MONTGOMERY COUNTY HISTORIC PRESERVATION COMMISSION
STAFF REPORT

Address:	3120 Lee St., Silver Spring	Meeting Date:	2/12/2019
Resource:	Contributing Resource Capitol View Park Historic District	Report Date:	2/6/2019
Applicant:	Kenneth and Sarah Olson Brian McCarthy, Architect	Public Notice:	1/30/2019
Review:	HAWP	Tax Credit:	n/a
Case Number:	37/07-18D (REVISION)	Staff:	Dan Bruechert
Proposal:	Material Change to Previously Approved Porch Addition

Re: Historic Area Work Permit for
 3120 Lee Street, Capitol View Historic District
 Addenda to HAWP: **Clad vs Wood Window /Door Narrative**

WEATHER SHIELD INSWING DOOR (6510)
Vertical Section

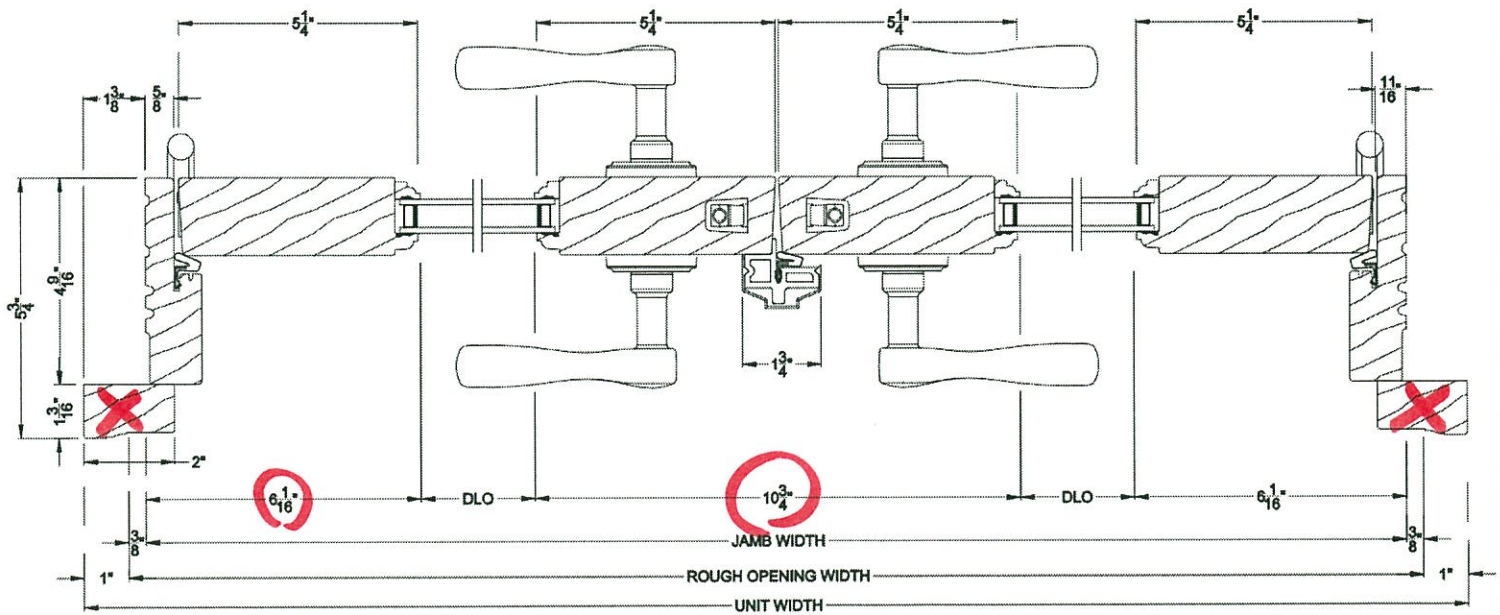
- 1) The door stiles and rails of the clad doors are approximately two inches narrower than the wood alternative.
 - a) This maximizes the glass to wood ratio, enhancing transparency.
 - b) It also puts the door rail width much closer to the sash width of the windows making for a more uniform and harmonious appearance.
- 2) The clad window unit/frame depth is 1-1/2 inch shallower than the wood alternative. Consequently, when viewing a gang of windows at an angle the continuity of the sash/glass plane will be maximized and projecting interruptions will be minimized.
